Execution CANopen-Slave Interfaces

1. Standard CANopen Slave Interface for Software 01

Type: BM4-O-CAN-03-00-00

Information of nameplate:

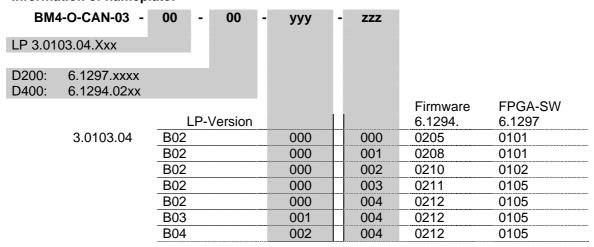
The printed circuit board 3.0103.04.B02 is the first official version.

The printed circuit board 3.0103.04.B03 is introduced with AT076 05 from March 03, 2005.

Optimized boot behavior (Reset level at the option modules)

The printed circuit board 3.0103.04.B04 is introduced with AT141_07 from May 05, 2007.

Optimizing of Assembly (No Boot Strip Loader Function)

The changes are uncritically for the software. New software also runs on old hardware version.
